# Access Compliance Report

## Public Rights-of-Way

### (Curb Ramps)

Intersection ID: 19953	Main Street: ARCHDALE_DR	Cross Street: OLD_PINEVILLE_RD	Location: SW
ADA ID: 1847DEFF0B96	Ramp Type: Perp	Initial Pass/Fail: Fail	Overall Compliance: No
Severity Score: 8.75			
Codes/Mitigation Info/Possible Solution		Field Measurements/Component Compliance

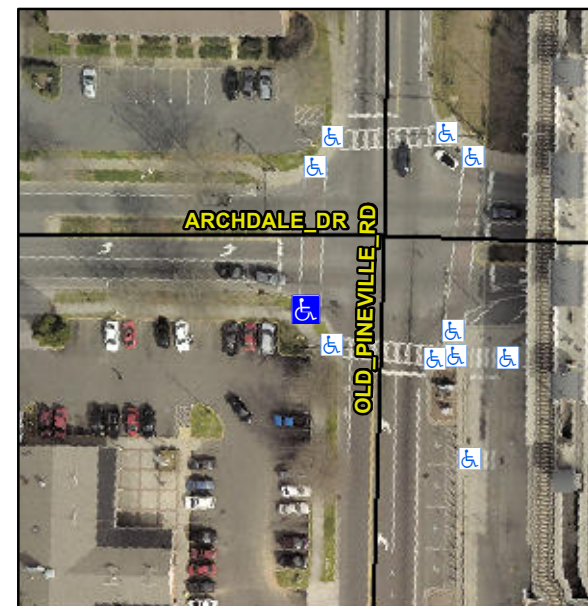
**Not Found, R304.5.1**

Compliance	Description	Data	Compliance	Description	Data
N/A	Ramp Length (in)	71.0	Yes	Ramp Slope (%)	8.0
No	Ramp Width (in)	43.5	Yes	Ramp XSlope (%)	0.1
N/A	Flare Type LT	N/A	N/A	Flare Type RT	N/A
N/A	Flare Slope LT (%)	N/A	N/A	Flare Slope RT (%)	N/A
N/A	Flare Traversable LT?	N/A	N/A	Flare Traversable RT?	N/A
N/A	Landing Length (in)	N/A	N/A	DWS Provided?	N/A
N/A	Landing Width (in)	N/A	N/A	DWS Contrast?	N/A
N/A	Landing Slope (%)	N/A	N/A	DWS Length (in)	N/A
N/A	Landing X Slope (%)	N/A	N/A	DWS Full Width?	N/A
N/A	Landing Curb? (Y/N)	N/A	N/A	DWS Offset (in)	N/A
N/A	Shared Landing?	N/A			
N/A	Gutter Ponding?	N/A	N/A	Gutter Slope (%)	N/A
N/A	Gutter Lip Ht (in)	N/A	N/A	Gutter X Slope (%)	N/A
N/A	Painted X Walk1?	Yes	N/A	Painted X Walk2?	N/A
	X Walk 1 Direction	To N		X Walk 2 Direction	N/A
N/A	X Walk 1 Width (in)	119.0	N/A	X Walk 2 Width (in)	N/A
	X Walk 1 Slope (%)	1.2		X Walk 2 Slope (%)	N/A
	X Walk 1 X Slope (%)	0.6		X Walk 2 X Slope (%)	N/A

**Remove & Replace Entire Ramp.**
